URBAN DESIGN CONSULTATION RESPONSE

Design Officer	Azhar Kapadi
Date	03.04.25
Application Reference	25/00149/VRCON
Address	Longley Hey Farm, Halifax Road, Littleborough, OL15 0LB
Proposal	Application for minor material amendment to approved planning application 23/01280/FUL for the erection of replacement dwelling

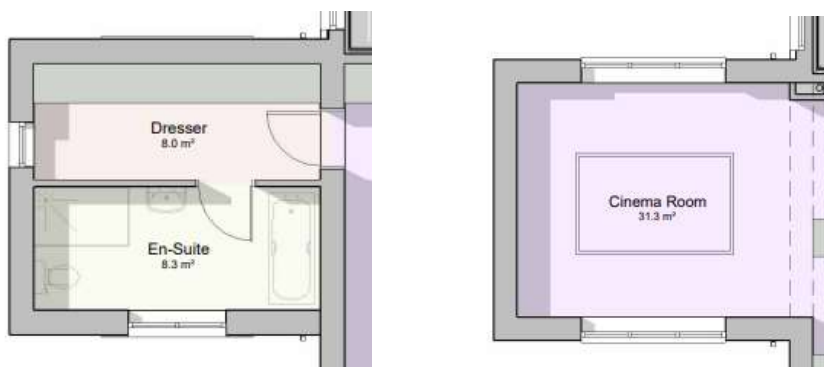
In principle, the scale and massing of the change is considered suitable. The changes however have resulted in empty / blank facades to the proposed double storey elements. This could benefit from internal rearrangement. The south elevation is 'quite busy' and would benefit from a revised design approach.

In principle, there is no reservation to the changes to the scale and massing of the building.

The removal of the chimney does reduce the quality / character of the development so I would advise that this is reinstated.

The east elevation has omitted large parts of glazing with an approach of opting for traditional fenestration instead. This is considered suitable. There is something nice about the ground floor windows (stone mullions) aligning with upper floor windows and this has been lost with the removal of the three pane window, replacing this with the relocation of the door. I would therefore continue the window to align with the windows above. Similarly the two storey element as part of this revision would benefit with a similar type of window/stone surround, to the upper floor. On the east elevation, the elevation looks blank at first floor level, so maybe a recess outline of stonework where a window and surround could have been would help reducing this elevation from being too empty and monotonous.

Similarly the gable to the north elevation, can something be done to prevent it from being an empty elevation? Presenting blank or largely blank elevations are not recommended and the plan can work more effectively to introduce some glazing and interest to these elevations.

I would encourage stepping this gable end (right hand side) to step in or step out slightly to provide some depth and relief to the elevation. This would help break up the elevation reinstating some of the interest that was provided previously in both the existing building and the previous application.

The glazing has considerably reduced also to the south elevation revision. The outline frame (oak) appears too dominant for both gables so I would advise maintaining this only for the left hand side as per the original permission and removing balconies and the frame to the right hand side. This would allow the two gables to sit more harmoniously with one another and avoid an overproliferation of glazed balconies and double doors at upper levels. This elevation as a whole seems 'too busy' and disrupts the character and style of the overall development. Previously, the glazed element worked more effectively in a single storey structure as a featured extension to the main building. Applying this to the gable at both levels does not however work well.
